Access Compliance Report Public Rights-of-Way (Curb Ramps)

Main Street: LULLABY_LN Cross Street: PERDIDO_ST Location: SE

ADA ID: RPAT220203155811 Ramp Type: Type 4 - Parallel Initial Pass/Fail: Pass Overall Compliance: No Severity Score: 5

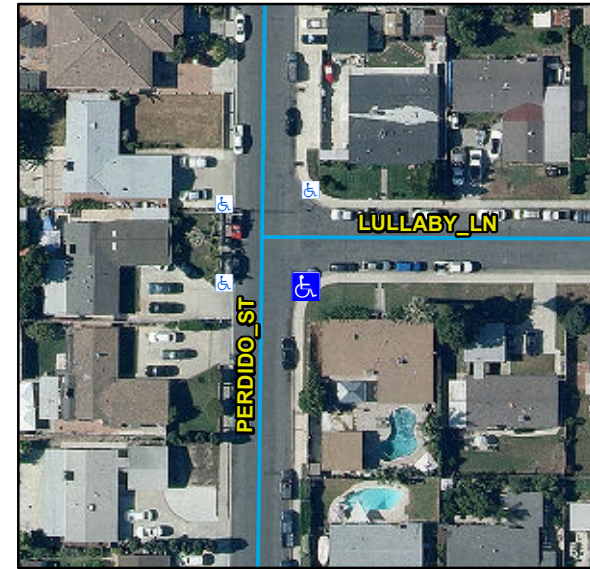
N/A	Ramp Inside Crosswalk 1	N/A	N/A	Ramp Inside Crosswalk 2	N/A
	Crossing 1 Slope (%)	6.1		Crossing 2 Slope (%)	N/A
	Crossing 1 Cross Slope (%)	0.4		Crossing 2 Cross Slope (%)	N/A
No	Gutter Ponding	Yes	Yes	Curb Slope	5.1
Yes	Gutter Lip Height (in)	0		Road Run Slope (%)	N/A
No	Gutter Run Slope (%)	6.4		Road Cross Slope (%)	N/A
Yes	Gutter Cross Slope (%)	1.3	Yes	Perpendicular Joint Present	Yes
Yes	Overall Surface Condition	Acceptable			
	Cross Gutter Present?	No		Spandrel Present?	No
	Replace Cross Gutter?	N/A		Replace Spandrel?	N/A

Possible Solutions:
Remove & Replace Gutter.
